May 21, 2015

Re: Bruce Hamler Water Treatment Facility
Rome, GA
PEC Project No. F15049

SECTION A-A
3/4" = 1'-0"

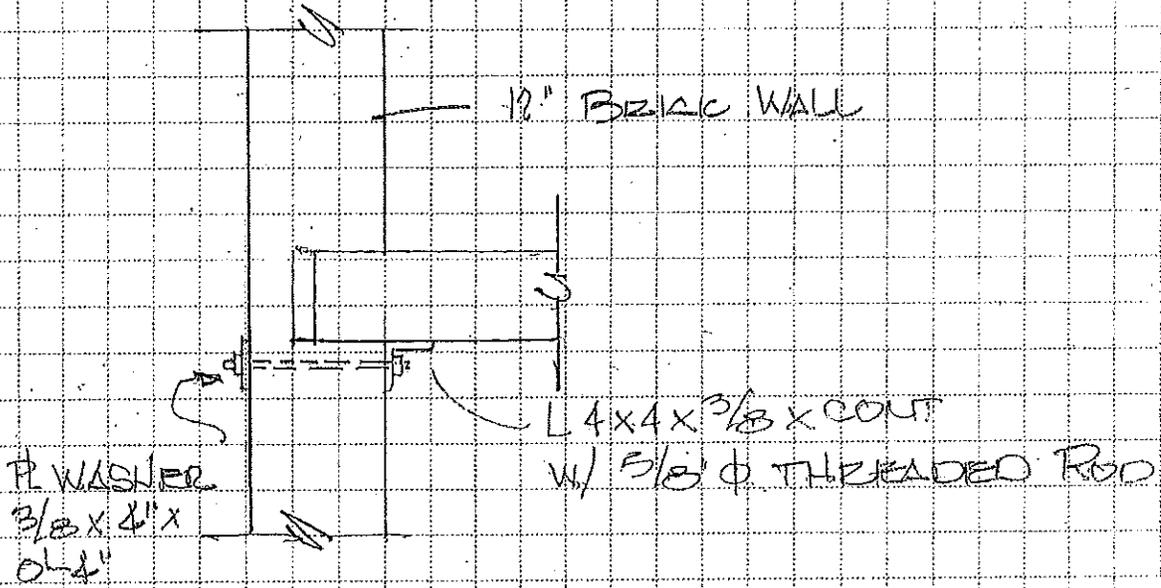
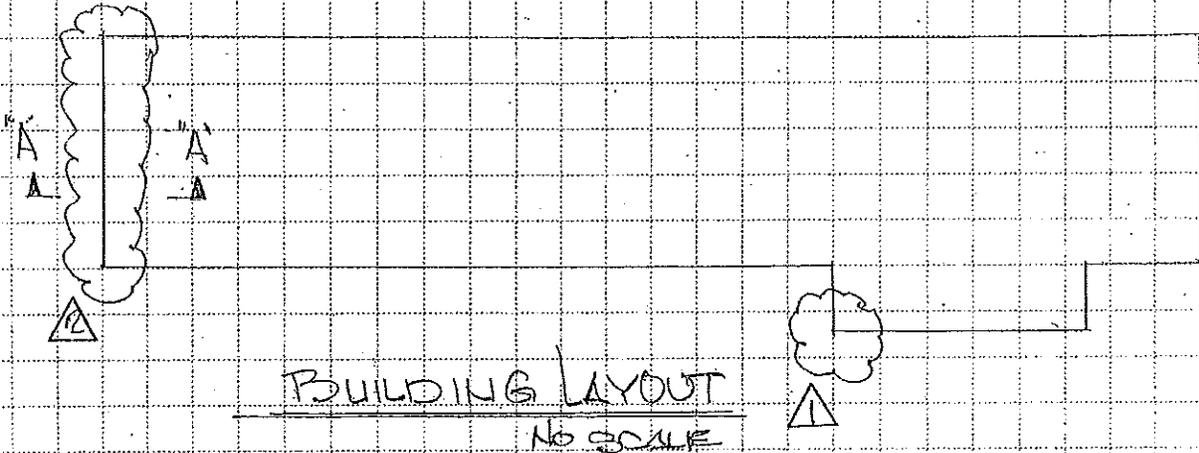
There are two areas that currently need attention. These two areas are clouded on the accompanying sketch. The first one is a stair-step section that has moved out of plane from the rest of the wall in the original portion of the building. The second area is the end wall of the addition where the outside course does not have bond brick tying the outside course to the two inside courses.

The first area is a corner of the initial portion of the building on the first level. It appears as water got into the wall, froze and caused some of the brick to be pushed out plane from the rest of the wall. This area is currently stable but unsightly. I recommend removing these brick that have moved out of plane, drilling and epoxying #3 dowels, 24" long, twelve inches into the existing brick. Drill these into the mortar joints in pairs on twelve inch centers vertically. Re-install the brick and cast stone, bonding them together as were the original brick and install truss type horizontal wall reinforcing (Dur-o-wal) on twelve inch centers.

In the second area, the wall appears to be moving out, away from the rest of the building. This wall provides vertical support for the framed floor. The gap that opened in the floor between the tile and the wall should be monitored. If the gap opens again, indicating continued movement, I recommend further review, but probably piers would need to be added and it could be necessary to reconstruct at least portions of the wall. At this point, I recommend bolting an angle L4x4x3/8 to provide additional support for the slab. See the sketch for a detail.
